Item ID: D206-642-341BL Accept *N900040100* Setup Start *NS1*
 Revision ID:
 Item Name: Replacement Skidtube (Fits LH or RH) Stop *NS2*
 Start Date: 1/28/2016 Start Qty: 1.00 *1* Cust Item ID:
 Required Date: 3/3/2016 Req'd Qty: 1.00 *1* Customer:
 Reference:

DRAWING NO. D2650	TITLE 206/407 SKIDTUBE ASSEMBLIES	REV. F	DART AEROSPACE LTD ENGINEERING ORDER		D.E.O. NO. D2650-F-1	SHEET NO. SHEET 1 OF 1	SCALE NTS
DRAWN <i>[Signature]</i>	CHECKED A.P.	MFG. APPR. <i>[Signature]</i>	APPROVED <i>[Signature]</i>		DE APPR. <i>[Signature]</i>		
DATE 12.10.12	DATE 12.10.22	DATE 12.10.22	DATE 12.10.22		DATE 12.10.22

CHANGE C'BORED WELDED CROSSBOLT SPACERS TO SWAGED SPACERS

DETAIL B

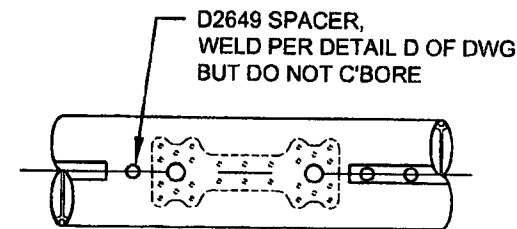
ADD DETAIL G BELOW, WHICH IS THE SAME SECTION VIEW AS DETAIL D OF DWG.
C'BORED HOLES ARE **NOW SWAGED** PER DETAIL G BELOW. FOR THE Ø0.375 HOLE THAT IS NOT C'BORED, WELD PER DETAIL D OF DWG (SEE AMENDED DETAIL B FOR REFERENCE).

DETAIL G

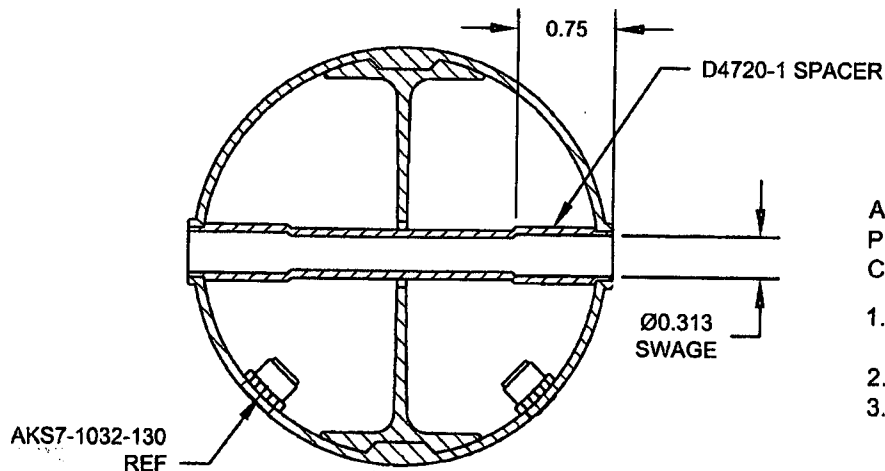
AFTER DRILLING AND BENDING ASSEMBLY
PERFORM THE FOLLOWING FOR Ø0.375 HOLES THAT ARE
CURRENTLY C'BORED:

1. INSERT D4720-1 SPACER, 16 PL (-1) OR 17 PL (-3)
OR 19 PL (-5) OR 23 PL (-7)
2. SWAGE TO Ø0.313 X 0.75 DP PER QSI 002
3. TRIM / GRIND FLUSH PER QSI 002
